Amendments to the Drawings:

REMARKS

The Office Action dated February 17, 2005 has been carefully considered. Claim 9 has been amended. Claims 1, 2, 4-17 and 19 are in this application.

Annotated Sheet Showing Changes

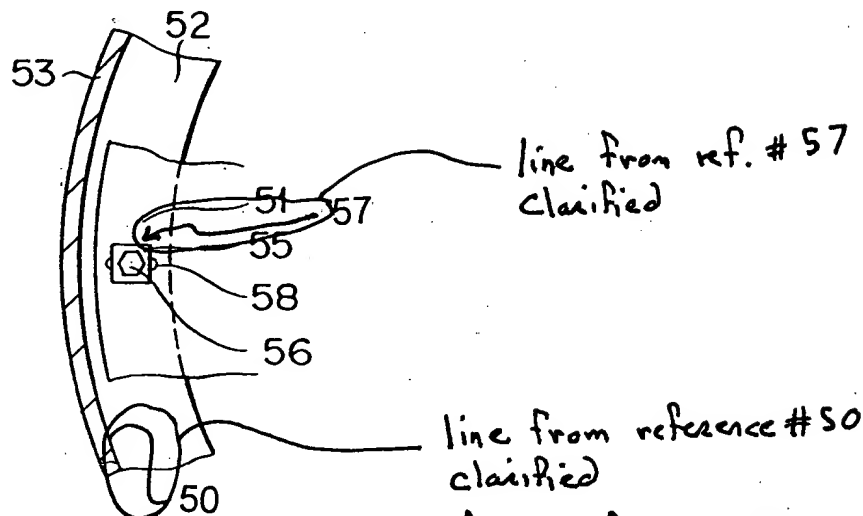
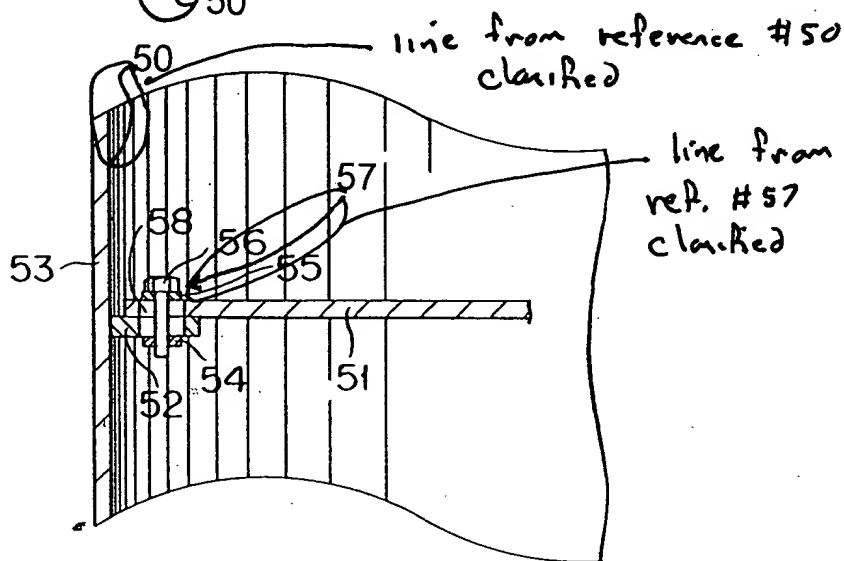
The Examiner indicated that both 57 and 55 and 50 and 52 appear to be pointing at the same thing. Applicants revised the drawings and clarified the reference lines and submit that 55 points to a washer, while 57 points to a fixing part which is a general area, including, bolt 56, washer 55 and nut 54. Applicants submit that 52 points to support ring 52, while joint part 50 points to the joint between support ring 52 and inner wall 53.

The attached sheet of drawings includes changes to Figs. 5a, 5b and 5c. This sheet replaces the previous sheet including Figs. 5a, 5b and 5c. Reference lines for reference numbers 50 and 57 have been clarified.
